Hochatown Walk Audit

November 26, 2024

In response to local feedback regarding the US-259 project through Hochatown, JP 34333(04), ODOT plans to incorporate sidewalks and crosswalks to improve walkability and pedestrian safety. To facilitate a more in-depth conversation, AARP and the Southeastern Regional Transportation Planning Organization hosted a Walk Audit in Hochatown. Due to the distance of the project, this walk audit looked a little different. Participants were shuttled to the north end of the project and then transported south along US-259 while having facilitated conversations at key locations as well as walking portions of the project that currently experience heavier pedestrian traffic.

Market at Local 259 / Lucian Sorrel Road / Choate Road (walked)

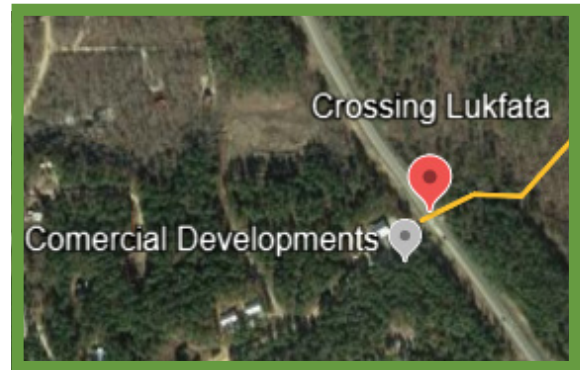
1. From north to south, US-259 is proposed to transition from 3 lanes to 5 lanes. Participants mentioned the need for wide turn lanes and protected crosswalks.

2. Participants would like sidewalks from this location to Lukfata Trail Road (Stop #3) to help commercial development.
3. People currently walk and bike this area. Having a sidewalk on one side of US-259 is better than none. If a sidewalk can only be built on one side of US-259, the preference is that a multi-use trail is built instead of a sidewalk. Additionally, if the sidewalk can only be on one side, it makes sense for it to be the west side at the north end of this area.

4. Again, the US Forest Service land on the east side of US-259 was suggested as a trail option for this area.
5. Participants voiced concern regarding elevation, utilities and drainage in this area. A crossing solution that was suggested is a drainage tunnel that could double as a pedestrian tunnel when dry. This would connect The Maze and Local 259.

6. The connection between Sugarberry Trail (between stop 3 & 4) and the residential development was also a concern and should be taken into consideration in the proposed design plans.

7. Participants requested a protected crossing in this area, potentially a HAWK (High-intensity Activated crossWALK) beacon due to the number of people walking from the cabins on both sides of US-259 to Local 259 and the Maze.

8. The City of Hochatown, landowners and business owners will need to discuss how the establishments will be connected to the sidewalk or multi-use trail.

Sugarberry Trail (didn't stop)

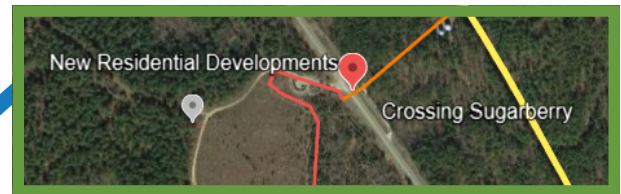
1. The city bought property in this area which may change the demand for pedestrian access.
2. There is a large numbers of rental cabins that are located off of this road.
3. There is also potentially additional commercial development coming to this area.

Carson Creek / Juniper Road (didn't stop)

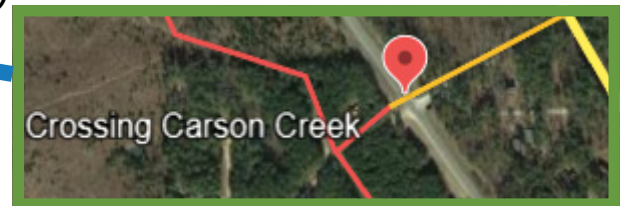
1. In the future there could be the need to have a crossing here.
2. There was conversation regarding a new residential development off of Carson Creek.
3. Carson Creek leads to boat ramps, RV camping, and several adventure destinations. This would mean a high probability for active living use of this road as well as recreational trailers. Carson Creek is connected to Stevens Gap via Indian Nations Hiking and Biking Trail.

Grateful Head / Girls Gone Wine/ Stevens Gap Road / Rock Oak Lane (walked)

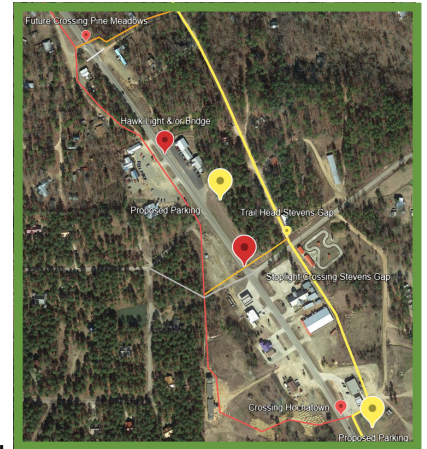
1. This area of US-259 is proposed to be 5 lanes.
2. Multiple pedestrians were observed walking on the east side of US-259. A vehicle was also observed crossing US-259 from move from one parking lot to another.

3. Due to the limited visibility at the north end of the area, a pedestrian bridge was suggested.
4. Sidewalks should be on both sides of US-259 and the north end should start at Carson Creek.

5. This whole area will need street and pedestrian lighting.
6. US-259 should feel like a small town downtown or "Main Street" through this area and should be pedestrian friendly.

7. The proposed north crosswalk looks good. Consider realigning the one to the south and making it a protected crossing (HAWK beacon).
8. Ideal speed should be 25 or 35 mph. Many drivers were not comfortable with people walking next to the highway. If possible, there needs to be a buffer between pedestrians and the back of the curb.

9. Warning devices such as pedestrian warning signs and rumble strips may need to be added to help slow traffic.
10. Concern was voiced regarding pedestrians trying to cross anywhere instead of just at the crosswalks. Maybe US-259 design can include physical deterrents to funnel people to crosswalks.

11. Proposed parking lot locations on the east side of US-259 were identified as just south of Spinner Trail and just south of Spearfish Road.
12. Some road realignment may make adding crosswalks easier.

13. A crosswalk is needed at the Stevens Gap Road light.
14. Once constructed, a zero-tolerance enforcement might help to maintain posted speeds.
